1. PURPOSE AND SCOPE OF THIS MEMORANDUM

The subject property is the Pembroke Police Station at 80 Center Street.

ii. Directional signage to primary uses within building

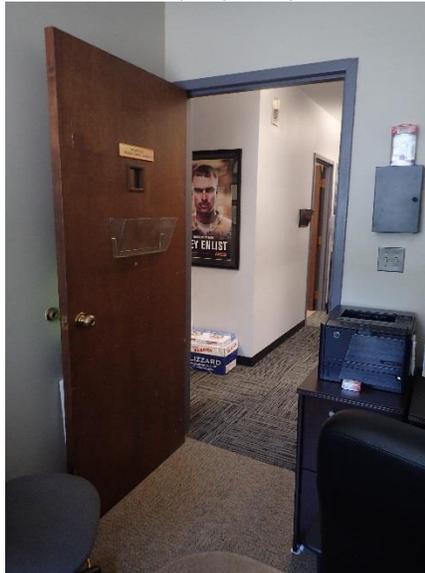
The interior signage at the Police Station is limited and typically does not meet ADA standards. Some permanent rooms and spaces are clearly identified, but the signage is not mounted at consistent heights or locations and lacks the required raised lettering and Braille characters.

However, we note that most public access to the Police Station is limited to the main entrance vestibule. Public access to other areas of the building is provided on an escort-only basis, so ADA-compliant signage is not a critical concern.

- b. Interior Signage  
Provide consistent ADA-standard signage for all accessible doorways, routes and spaces.
- c. Door Hardware – priority items  
Provide lever-handle hardware at any doors expected to be used by the general public, whether escorted or not. Ensure single-action release (from the room or exit side) of doors subject to locking (i.e., no separate deadbolts, etc.)

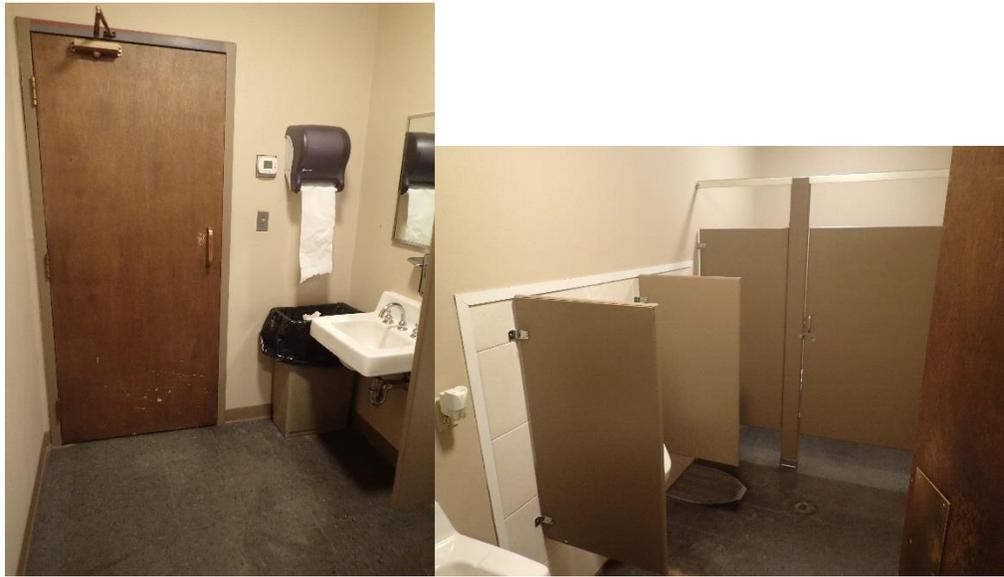
As noted above, the Interior signage at the Police Station does not generally meet ADA standards.

iv. Basement and Second-floor areas

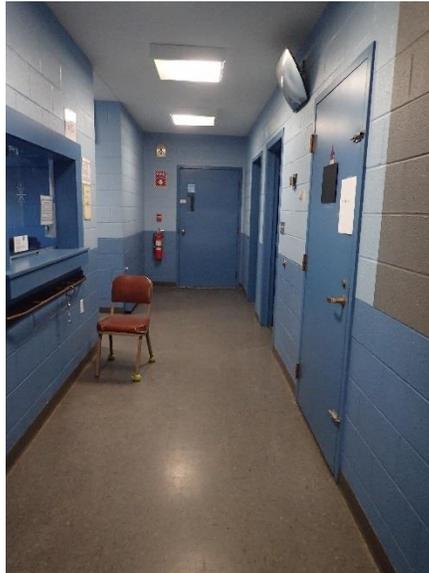
There are employee facilities, storage and utility areas in the basement and on the second floor. All are accessed by stairs, and there is no elevator or chair lift. None of these areas are open to public use, and they were therefore not evaluated for accessibility.
